CITY OF PORTLAND

BUILDING PERMIT

Job ID: 2012-06-4259-ALTR

has permission to build an attached garage with living space; interior/ exterior renovations (Single Family Residence).
provided that the person or persons, firm or corporation accepting this permit shall comply with all of the provisions of the Statues of Maine and of the Ordinances of the City of Portland regulating the construction, maintenance and use of the buildings and structures, and of the application on file in the department.

CUPOLA FLOOR PLAN

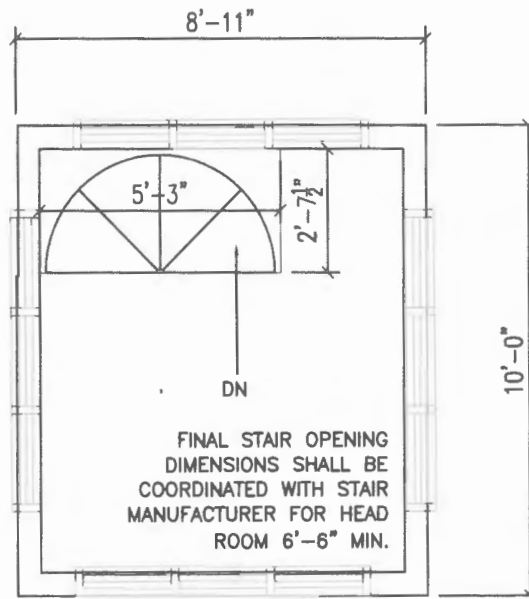
Because of the extent of renovation, Fire Prevention (I CC'd Capt. Pirone) is going to take a look at the permit. Can you provide a written response vs marking the plans- to the items listed below: The stairwell to the copula would be the only sketch required prior to issuance.

- For our Fire Prevention Bureau- can you indicate if the addition/ renovated area will (or will not) exceed _50_% of the total completed structure?
- I spoke with my Director, the "Cupola" would need a compliant stairwell (she can be reached at 207.874.8703 if you have questions).

SEE SPECIFICATIONS
FOR STAIR DETAILS AS
DESIGNED BY STAIR
MANUFACTURER

13 EQUAL RISERS @ 9 3/8"

FIELD VERIFY DIMENSIONS
BEFORE STAIR FABRICATION
